**Subject:** Fw: Yonge Bernard KDA Secondary Plan - North Elgin Centre Inc. - submission to May 13 public meeting

**Reference: North Elgin Centre Lands at Yonge & Bernard Key Development Area  
Secondary Plan –Technical Assessment and Development  
Recommendations**

**Re: Town File nos. D01-16002, D02-16012, D03-16006  
12 & 24 Naughton Dr., 0, 11014, 11034, 11044 & 11076 Yonge St., and  
0, 47 & 59 Brookside Rd.  
Yonge Bernard Key Development Area Secondary Plan**

**Re: Yonge Bernard Key Development Area Secondary Plan**

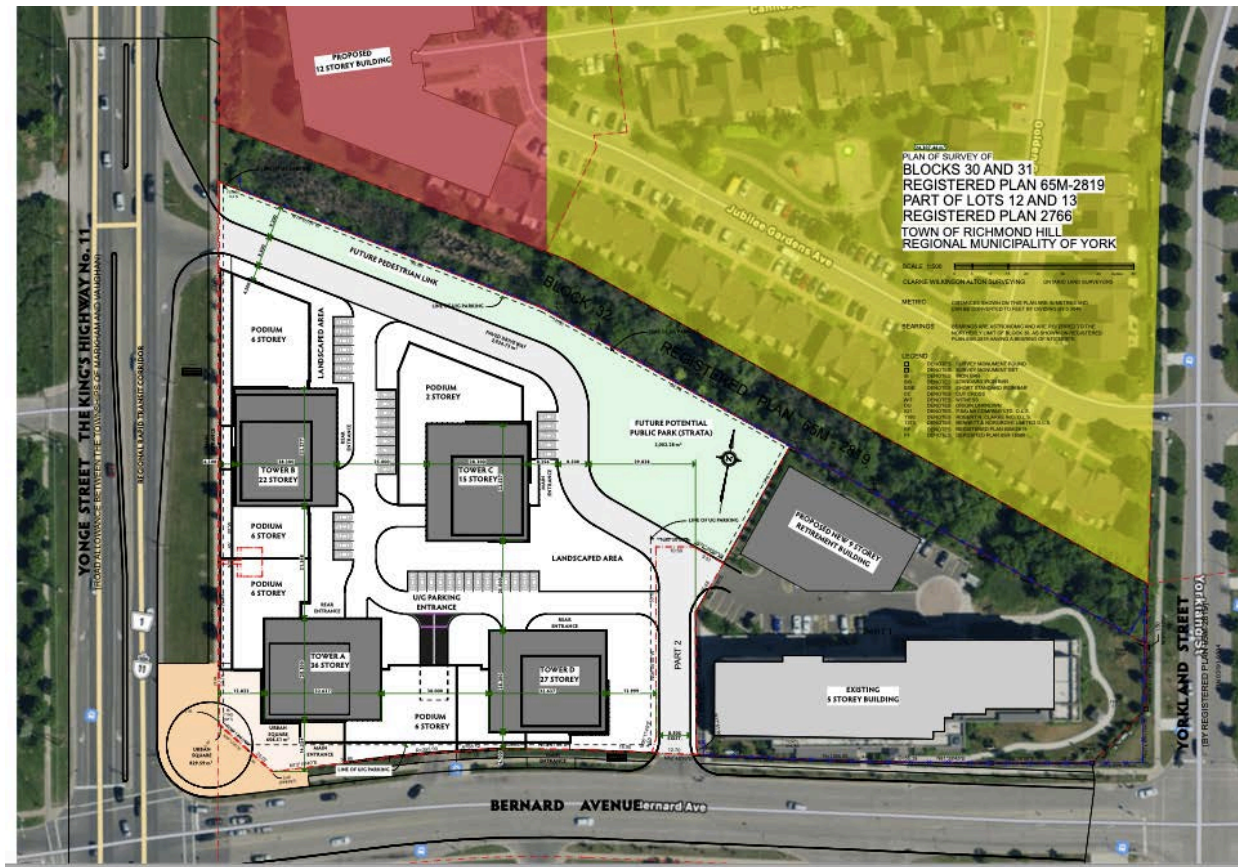
In the March 15, 2020 letter, TRCA recommend a 10 m wide OS zone be applied along the entire northern property boundary (across both 10993 Yonge St. and 70 Bernard Ave.) to provide a flood plain buffer and recognize potential channel overtopping on 70 Bernard Avenue. This buffer would be subject to refinement when redevelopment is applied for on the affected properties. TRCA further recommend that a 10m wide MVPZ (buffer) be applied from the meander belt limit which, in the circumstances, would be from the limit of the gabion baskets on both sides of the watercourse within the channel. TRCA letter further confirms that there is very little ecological connectivity and value between the channel and the surrounding area.

The location of the channel is referenced in emails from MPlan Inc. to the City and TRCA and shown in green on NEC's Block concept plan below. The channel block is legally described as Block 32 on a registered plan 65M-2819. Block 32 is located between two highly urbanized areas, see image below.

In our assessment, we have found no justification, nor need for a 10m OS buffer along the north limit of subject property. We believe no buffer is required from the channel block – Block 32 at this time for the following reasons:

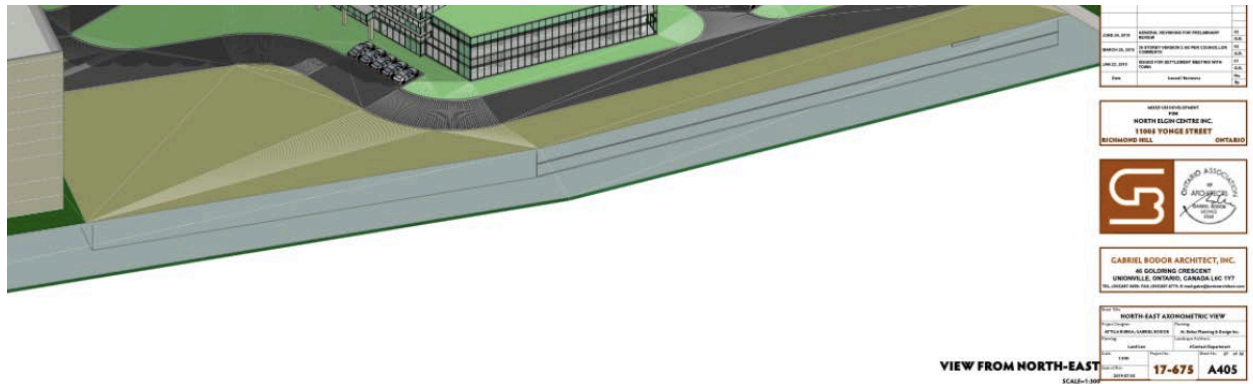
NEC's concept plans (June 2019) show 2 levels of below grade garage with a park at grade within the requested 10 m buffer zone. The garage wall would extend 6m below grade. This below grade structure is proposed to be located within a metre of the north property line (which is the south limit of Block 32). See image below.

It was also found that concerning the OS designation in the zoning bylaw, the Revised Draft Zoning By-law Schedules (February 2020) show an OS designation along the subject property however, no such designation on the lands to the east – 70 Bernard and the west of Yonge Street. The zoning setback along the channel for both NEC and 70 Bernard is stated to be 0.0m above and below grade.
